#### Development Application: 898 Elizabeth Street, Zetland - D/2023/243

File No.: D/2023/243

#### Summary

Figure 19: Shadow diagrams

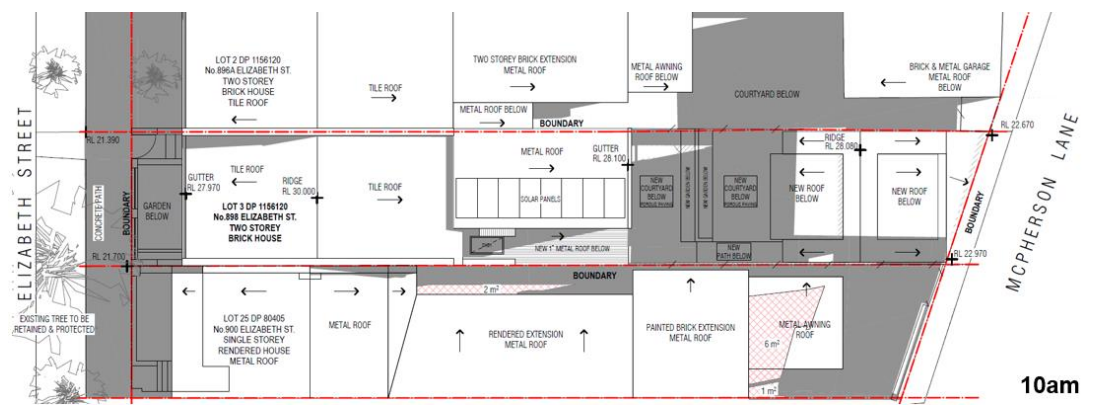
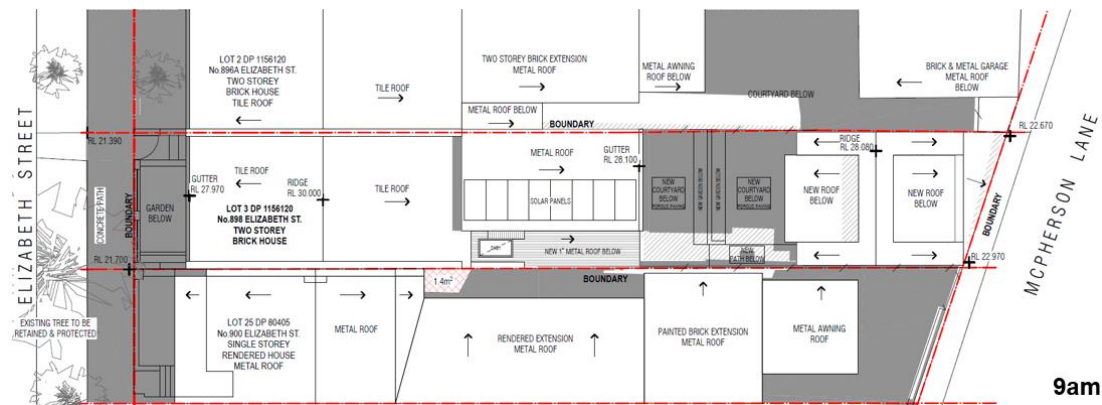
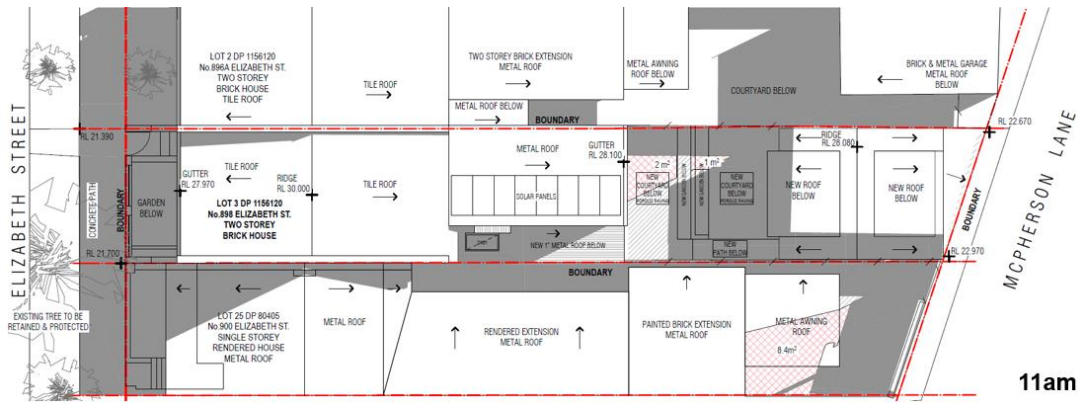
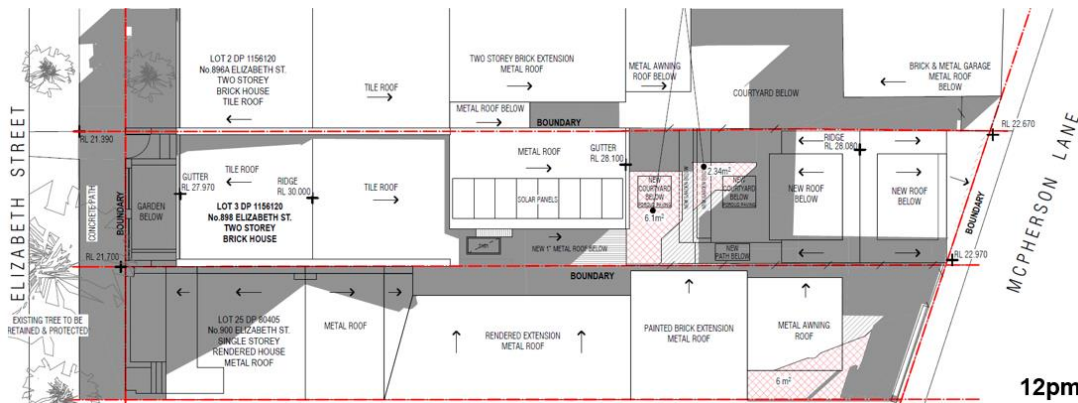
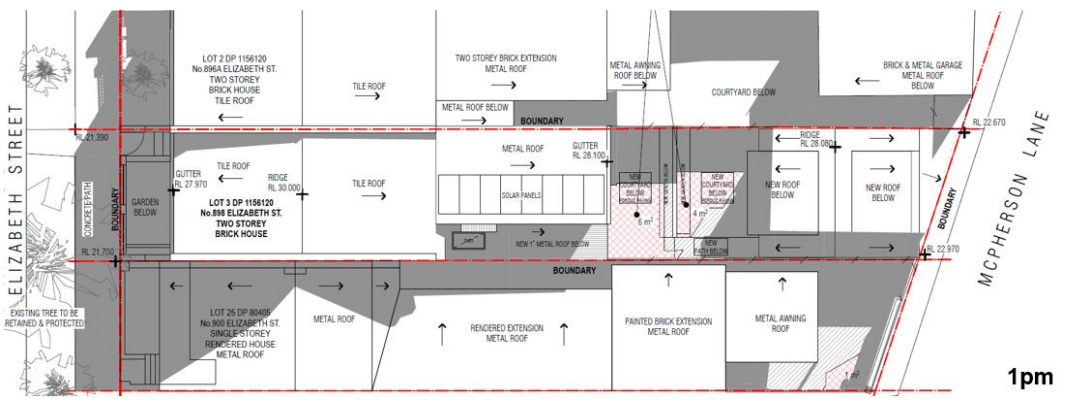
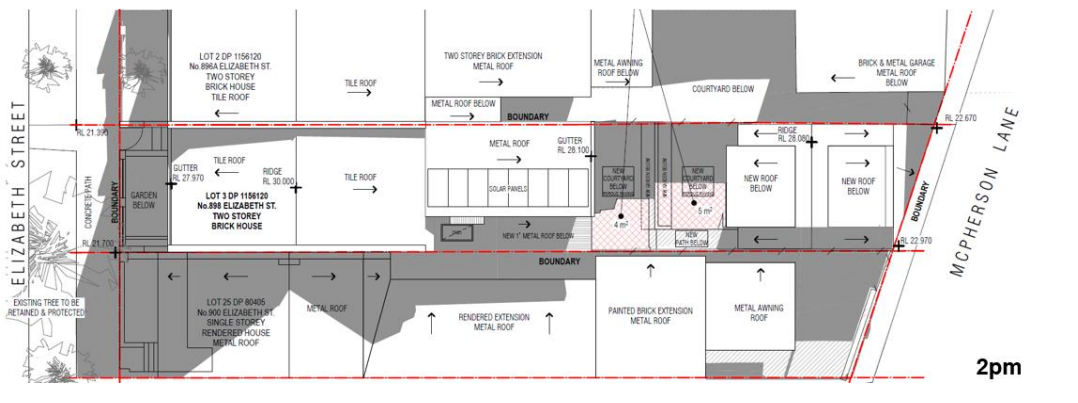
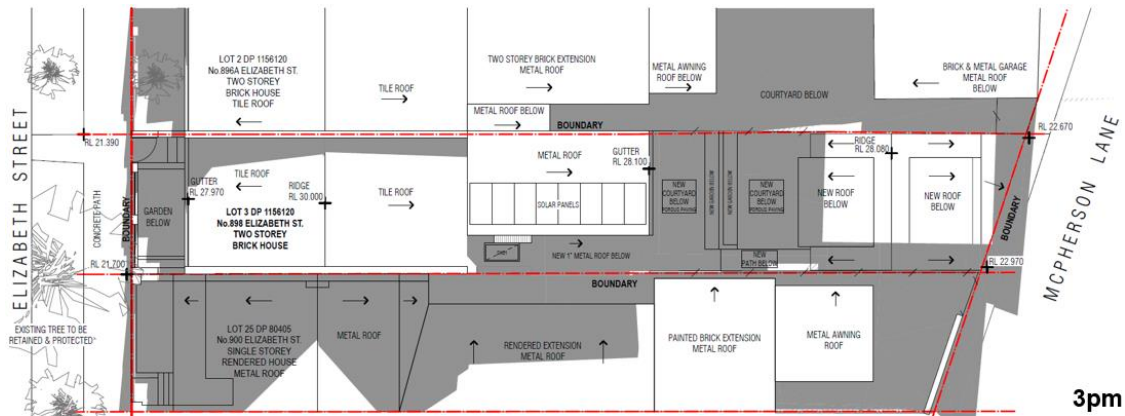
31. In relation to the subject site, the shadow diagrams demonstrate that the proposed development will achieve the recommended level of solar access, being:
- over two hours of direct sunlight to at least 8m<sup>2</sup> of the private open space, located between terrace (principal dwelling) and the secondary dwelling, from 12noon to 2pm; and,
  - over two hours of direct sunlight to at least 1m<sup>2</sup> of the terrace's north-east facing living room glazing from 11am to 2pm.

32. In relation to the adjoining property to the south, the ground floor rear building line of the existing single-storey terrace and the approved development is the same. That is, the location and size of the private open space is maintained. The existing metal awning roof also does not deter direct sunlight to the ground of the private open space. The metal roof will be removed as part of the approved development. Therefore, it is possible to rely on the above shadow diagrams to determine the level of solar access for both the existing situation and that of the approved development.

33. The shadow diagrams above demonstrate that the proposed development cannot maintain the recommended two hours of solar access to the private open space of the adjoining property to the south, only achieving direct sunlight to approximately 6m<sup>2</sup> of the adjoining property's private open space between 10am and 12pm. However, the design of the secondary dwelling has been amended to achieve a bulk that is comparable to the other laneway structures along McPherson Lane, particularly those at the rear of 894 and 896 Elizabeth Street to the north.

- (d) the narrowness of the adjoining site means its side boundary fence will overshadow the private open space throughout the day;
  - (e) the northeast orientation of the adjoining site also means that the rear boundary fence and roller door will overshadow the private open space in the morning, further limiting opportunities to achieve a compliant level of solar access without limiting the development opportunity of the subject site; and,

- (f) the direct sunlight is provided to the portion of the private open space directly adjacent to the indoor living area, where it is most likely to be used as an extension of the internal area and best contributes to the residential amenity of the adjoining site.

Figure 20: Solar access analysis - existing side windows

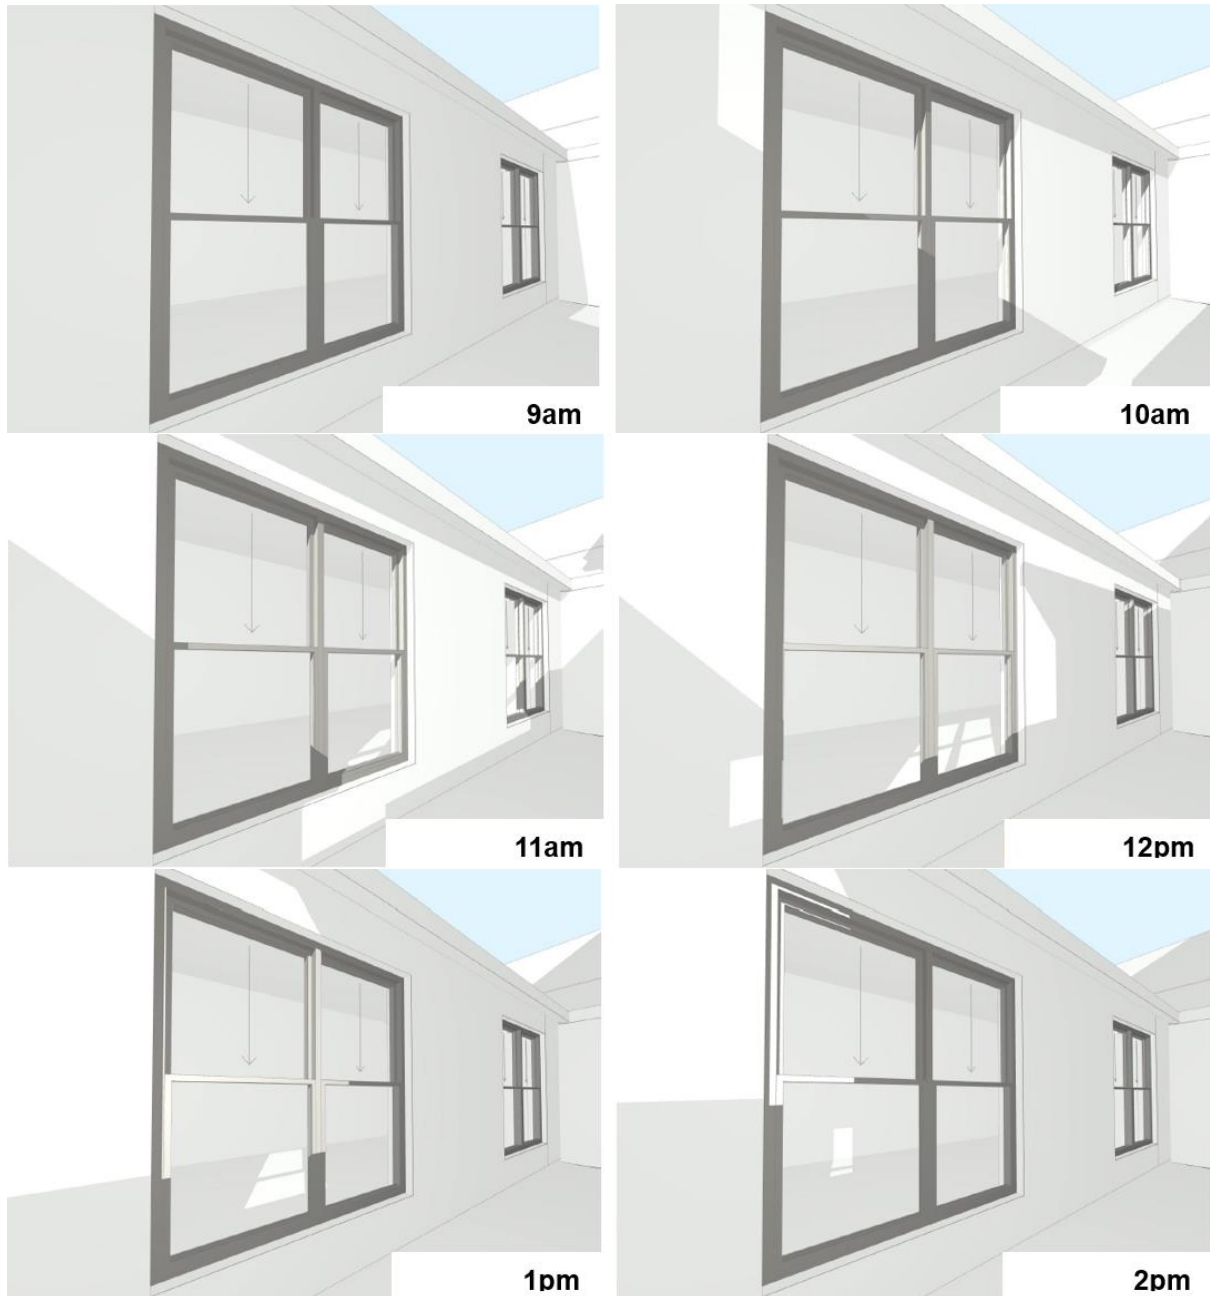
35. Notwithstanding, the elevational solar analysis (reproduced in Figures 20 and 21 below) demonstrate that the proposed secondary dwelling will maintain over two hours of direct sunlight to over 1m<sup>2</sup> of the existing north-facing side living room windows and the approved north-east facing living room glazing of the adjoining property, respectively. These exceed the recommended level of solar access.
